ADDENDUM

Project: Grand Lake St. Mary's State Park, Park Office Renovation
Project No.: DNR-250013
Date: October 21, 2025
Addendum No.: 1

B500.1 ADA CLEARANCE
A500.1 SCALE: N.T.S.

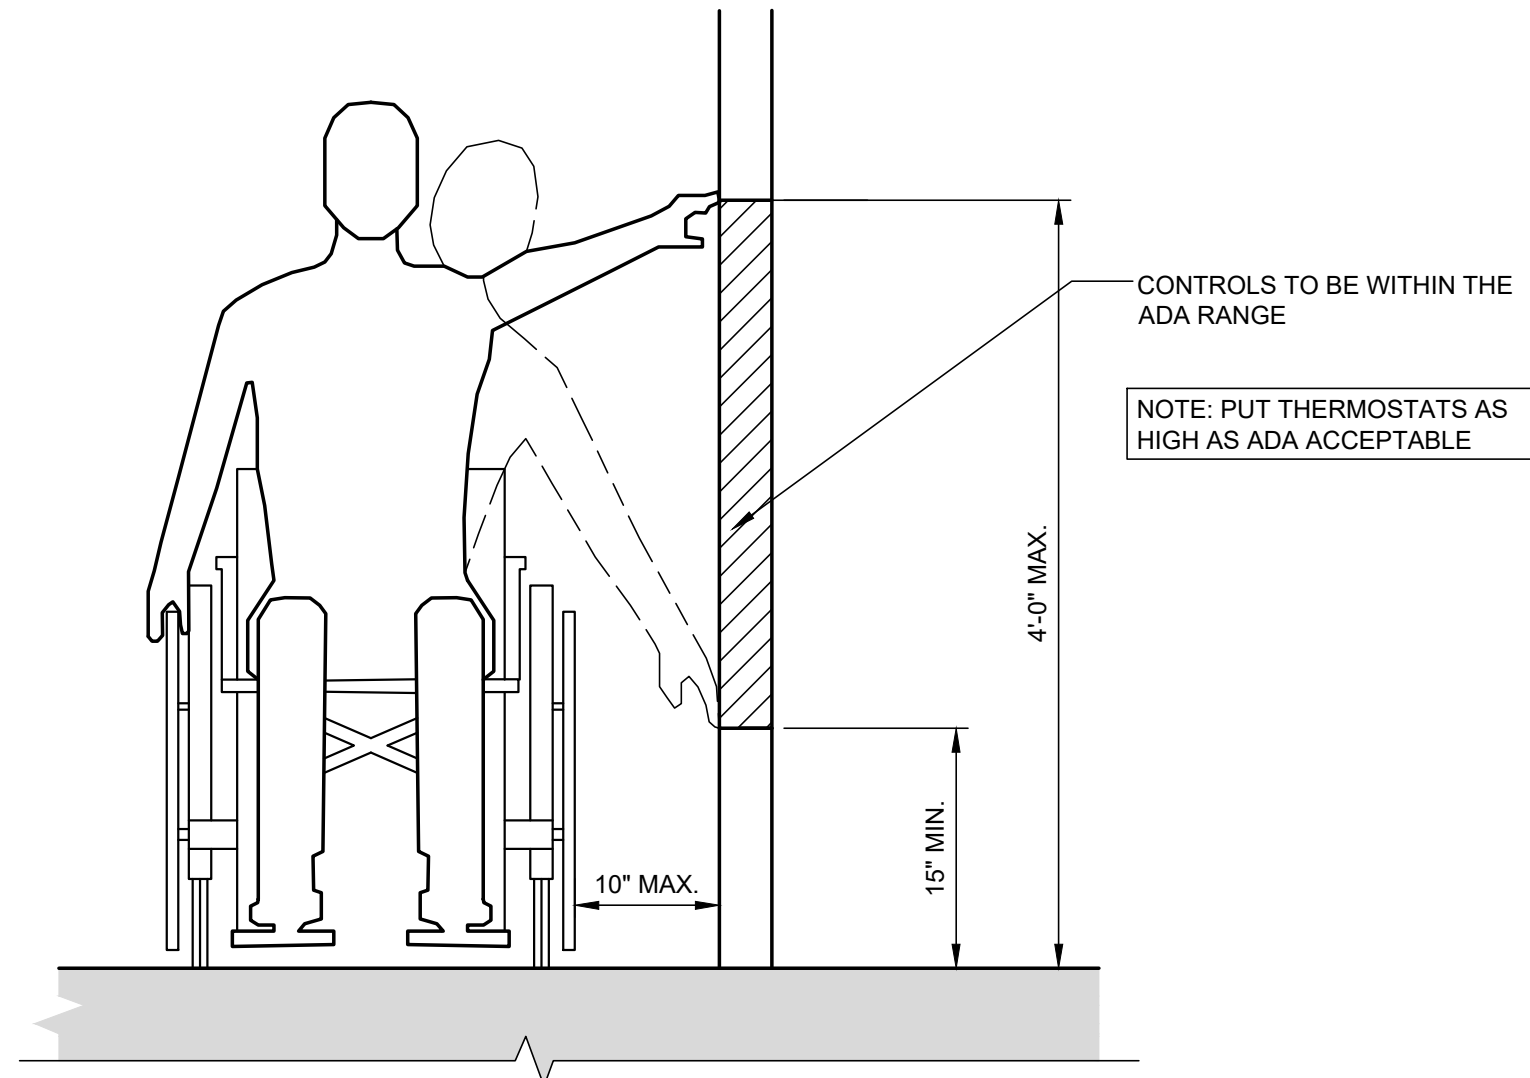
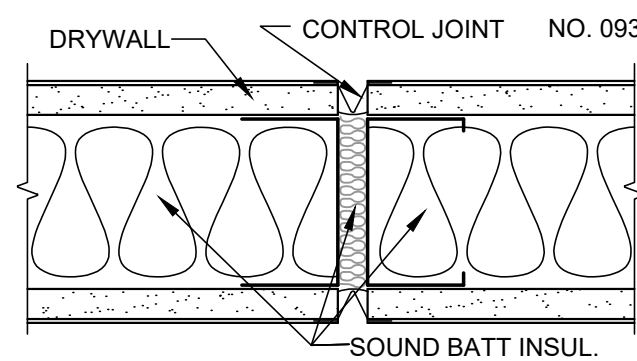
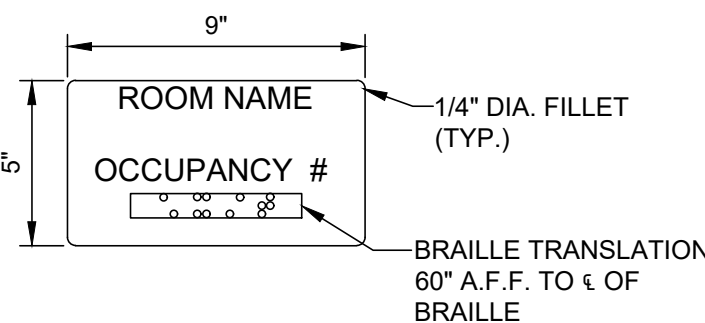
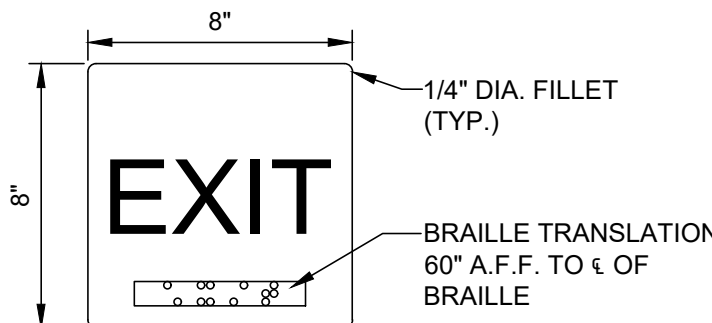
Item 8 – A500.1 (Revised)

- Before final floor finish is installed in drained areas of restrooms, floors shall be water tested / flooded to insure no puddling and positive drainage occurs before final finish coat is applied.

OFFICE 116
K200.1
A900.4
SCALE: 1/4"=1'-0"

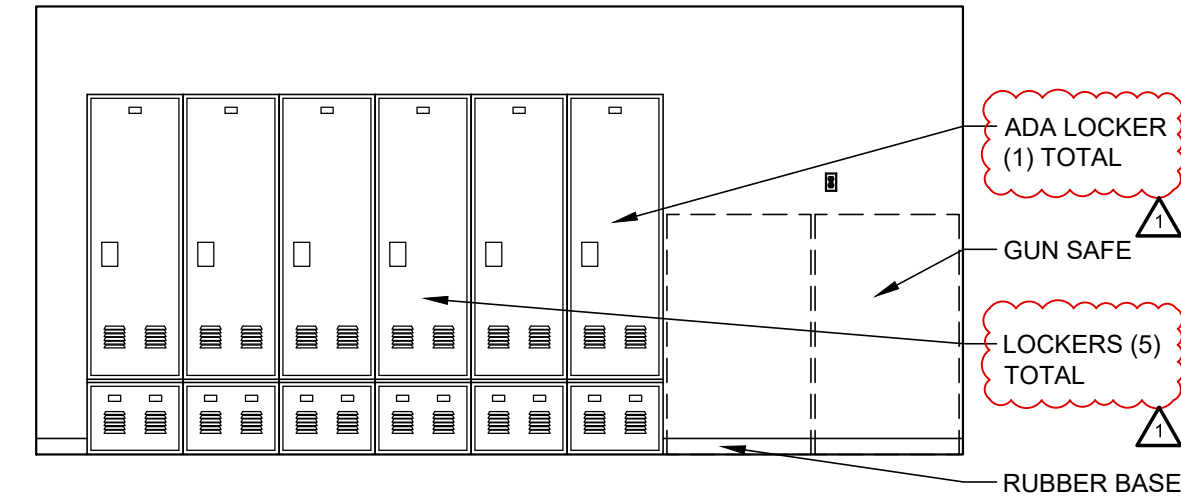
Item 9 – A900.4 (Revised)

- One of the lockers in the office 116 interior elevation K200.1/A900.4 was changed to an ADA locker.

- A. Provide a quantity of (5) 24"Wx36"Dx90"H law enforcement lockers in Office 116.
- B. Provide a quantity of (1) modified ADA accessible law enforcement locker in Office 116.
 - 1) Modified ADA accessible law enforcement locker shall be same dimensions and have same components as standard unit, however shelf, rod, hooks, and additional side compartments shall be below 48" A.F.F. to meet accessibility guidelines.

E100.1

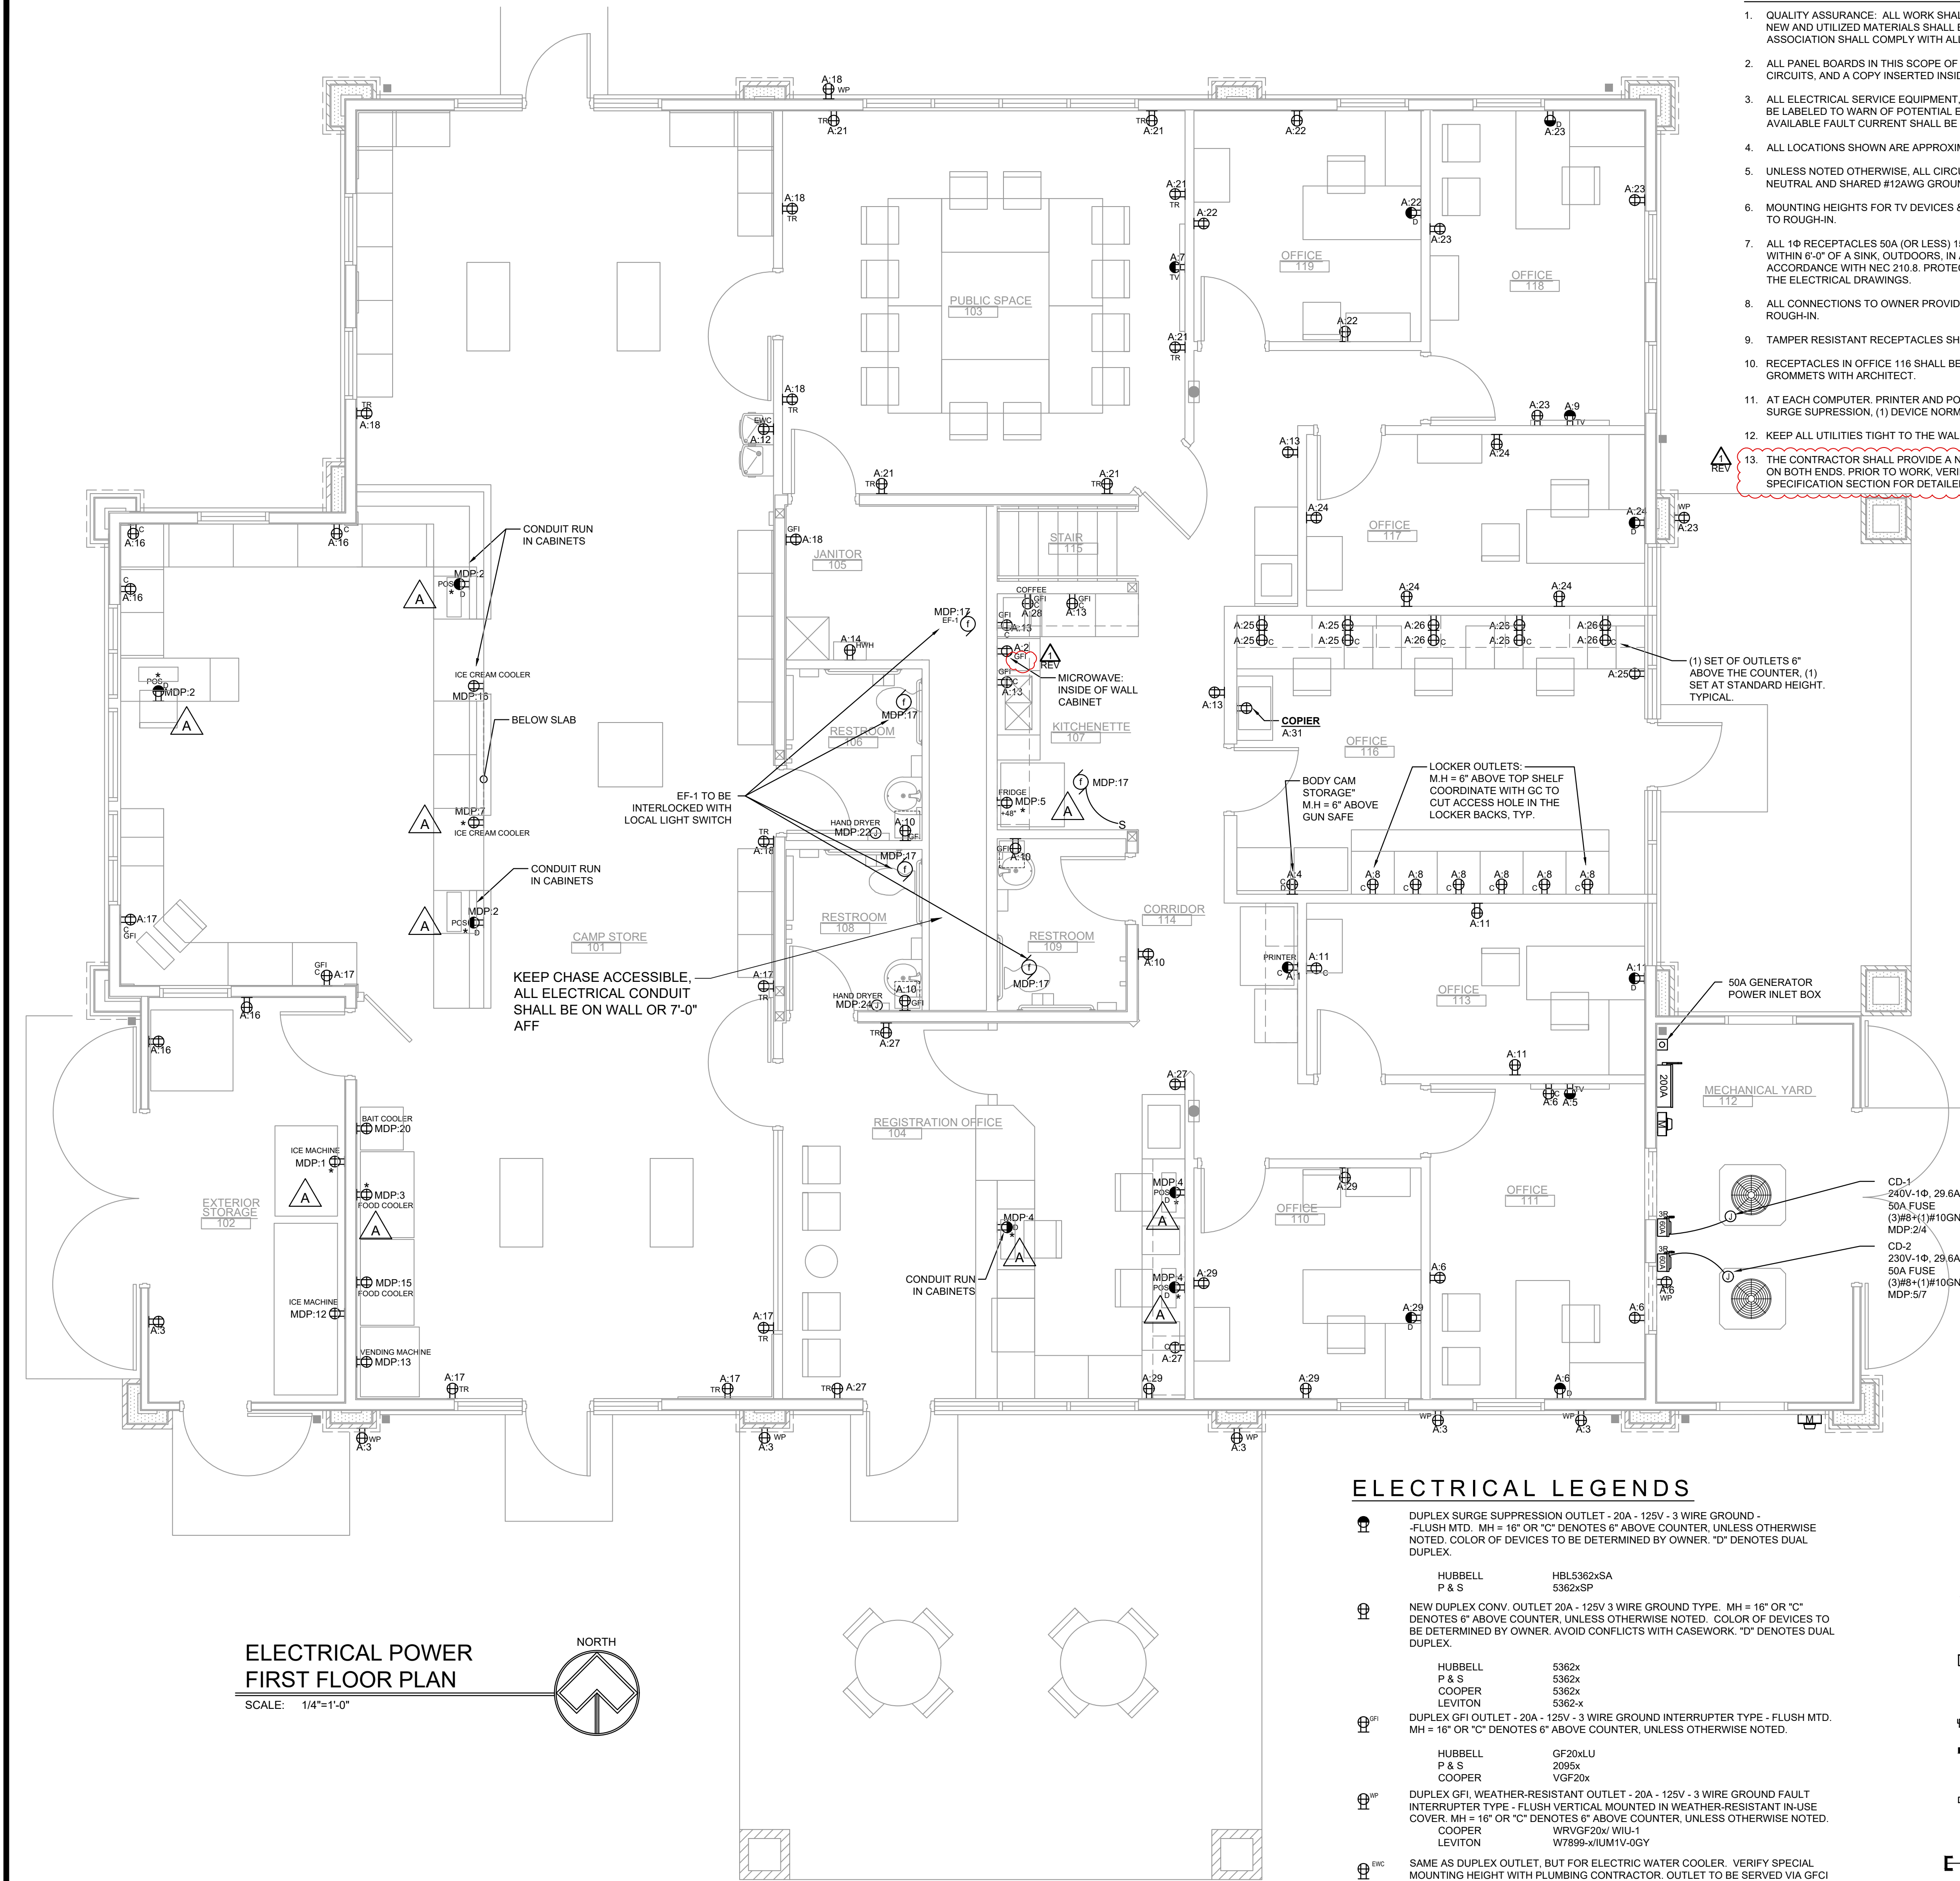
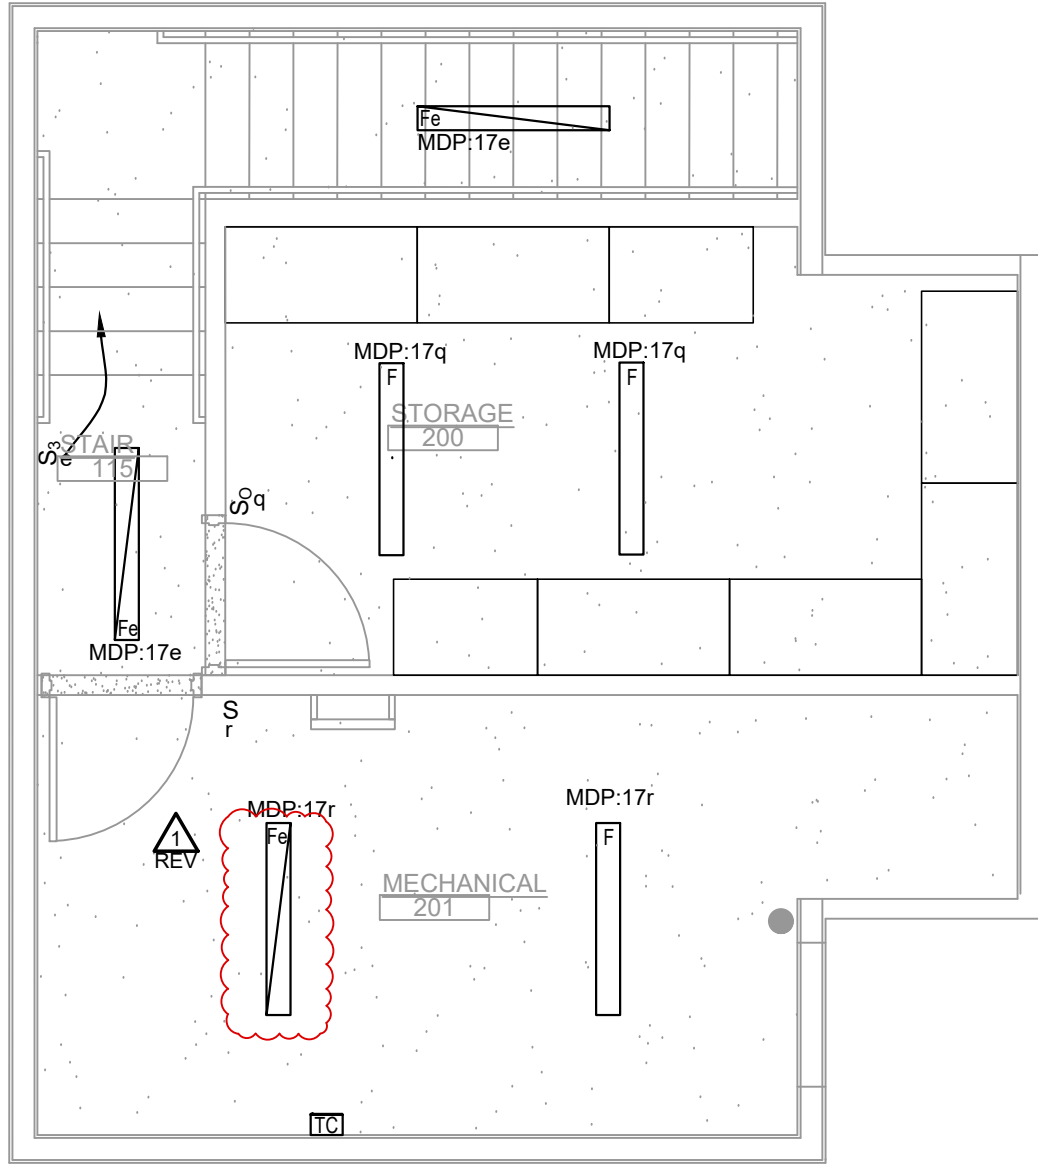
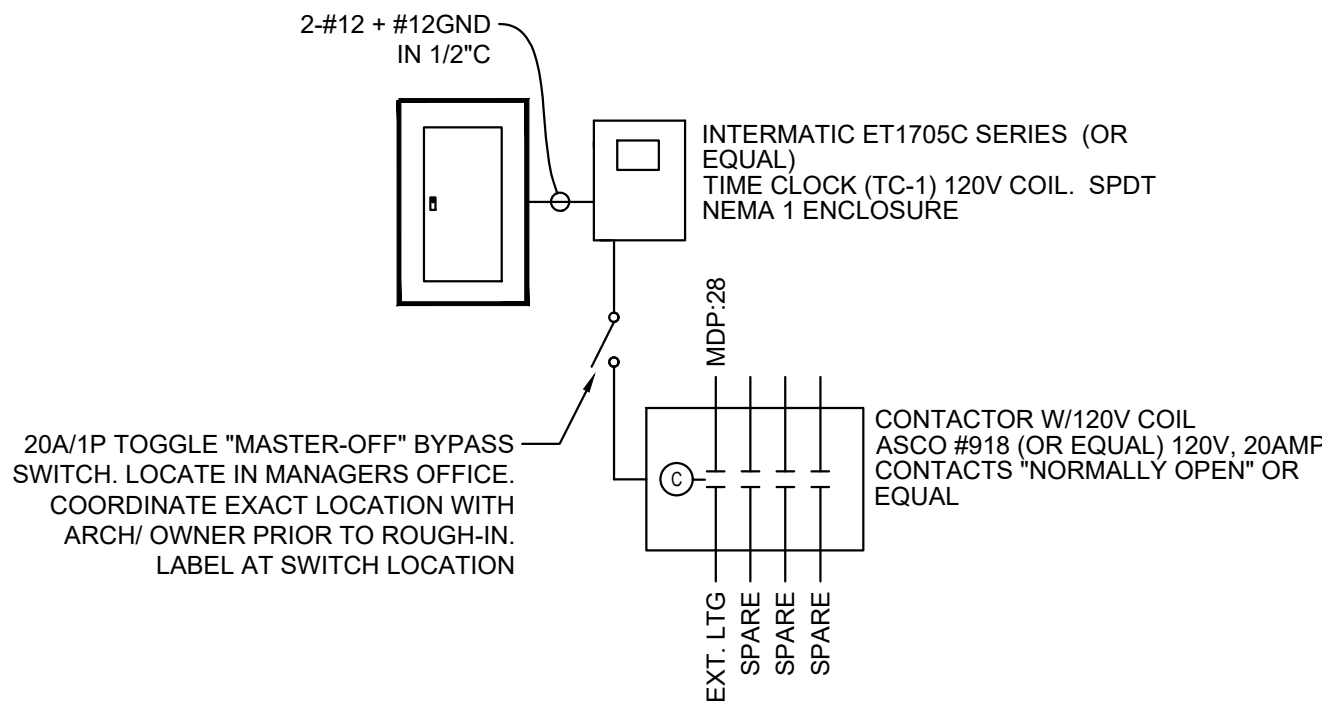
Item 11 – E100.1 (Revised)

- (1) Additional battery option has been added to light fixture “B” in the corridor. See revised sheet E100.1. Total of 4 emergency lights in the corridor.
